WEST SUSSEX COUNTY COUNCIL CONSULTATION

TO:	Arun District Council FAO: Michael Eastham
FROM:	Stephen Gee WSCC - Highways Authority
DATE:	10 February 2022
LOCATION:	Land west of Tye Lane Walberton
SUBJECT:	WA/127/21/OUT Outline planning application with all matters reserved, other than means of access, for the construction of up to 131 No dwellings (30% affordable homes) and amendment to boundary of garden land to serve adjoining property (resubmission following WA/68/20/OUT). This application affects the character & appearance of the Walberton Village Conservation Area & is a Departure from the Development Plan.
DATE OF SITE VISIT:	24/11/2021
RECOMMENDATION:	More Information
<u>S106</u> CONTRIBUTION TOTAL:	n/a

Tye Lane

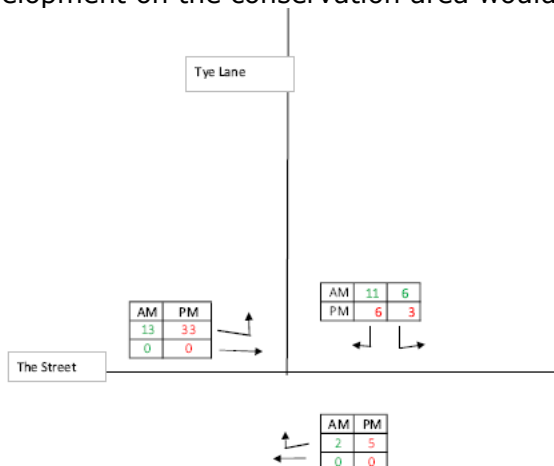
A 1.5m footway is to be provided along the western edge of Tye Lane and will provide connections into the development west of Tye Lane and to the Street. As a result of the footway the carriageway width will predominantly be reduced to 4.8m to 5m. A short section (10m) would require the width to be further reduced to 4.1m (whilst only providing a 1.3m footway). The works have been subject to stage 1 RSA with an agreed designers response and are considered acceptable by WSCC.
